Description of Changes

Item	Control (ME6000A_MAIN -> OTR_PF1_23)
Before	 The image shows the ME6000A_MAIN control board. It is a yellow PCB with various components including capacitors, resistors, and integrated circuits. A QR code is visible on the board, and the text 'ME6000A_MAIN' is printed. A warning label 'WARNING HIGH VOLT' is also present.
After	 The image shows the OTR_PF1_23 control board. It is a green PCB with various components including capacitors, resistors, and integrated circuits. A QR code is visible on the board, and the text 'OTR_PF1_23' is printed. A warning label 'WARNING HIGH VOLT' is also present.

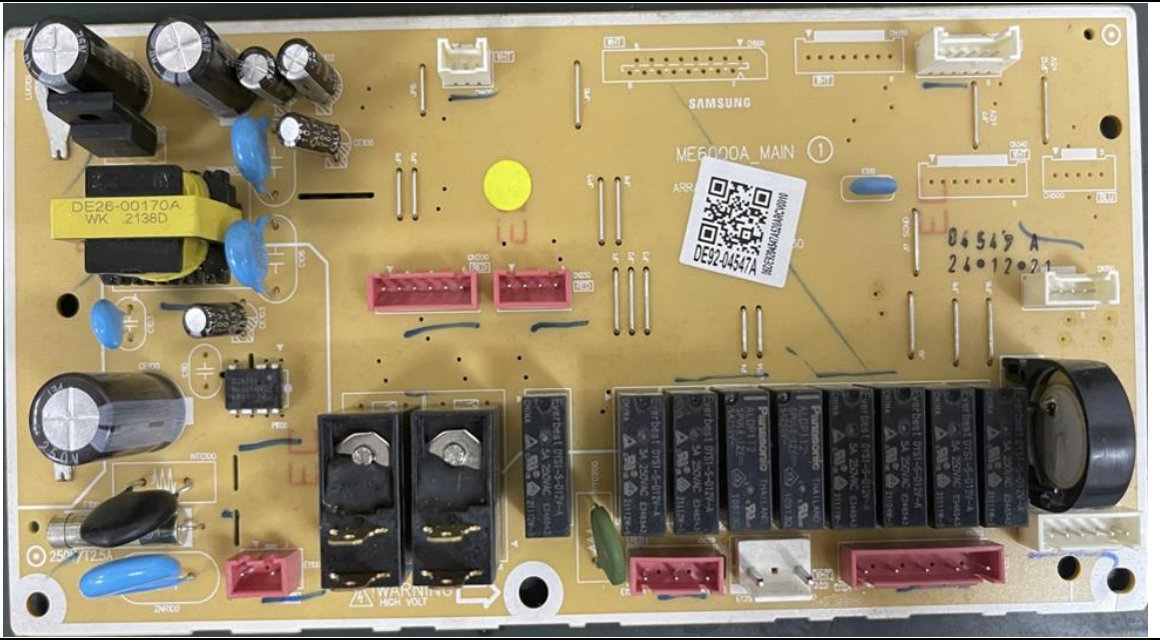
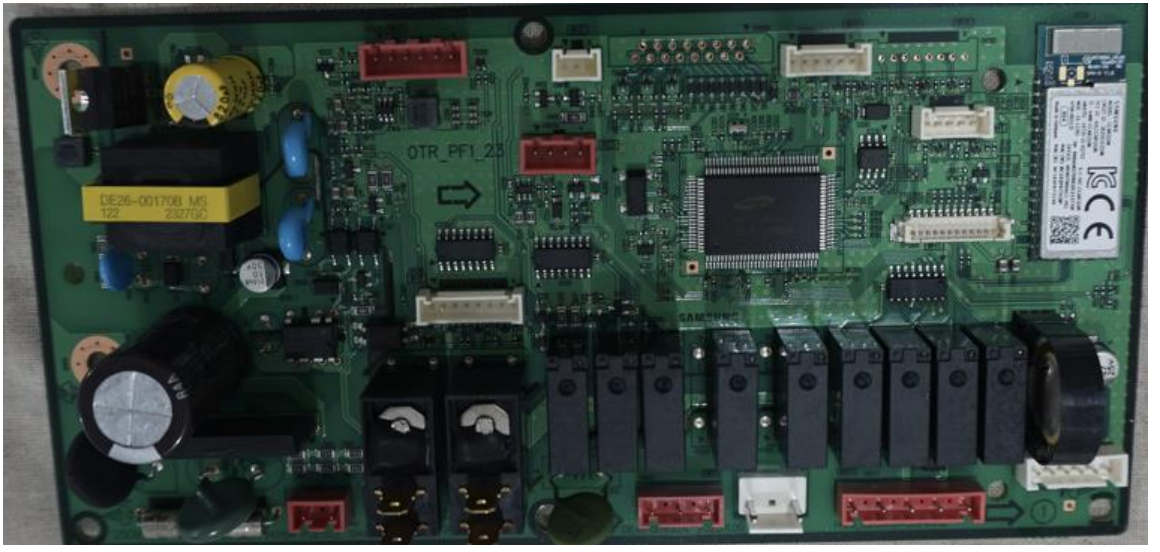
- There is change of control board
 - 1) Add wireless module by FCC certified
 - 2) New control board (Non-transmitter portion)
 - Overcurrent protection design (Fuse+add NCT)
 - Temperature protection design (add OTP circuit)
